WARRANTY BULLETIN

WB12-33

SUBJECT: WHEELCHAIR LIFT SLIDING DOOR HINGE

BOLTS TIGHTENING

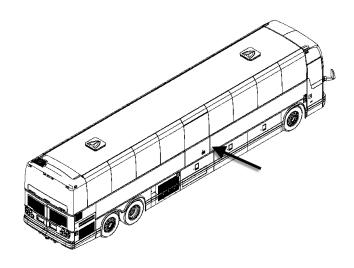
On the vehicles affected by this bulletin, the wheelchair lift sliding door hinge bolts need to be tightened to ensure proper torque is applied.

Procedure should be performed one bolt at a time to preserve door adjustment.

- 1. One at a time, each bolt should be un-screwed one turn and re-tightened to 43 lb-ft.
- 2. Apply torque seal.
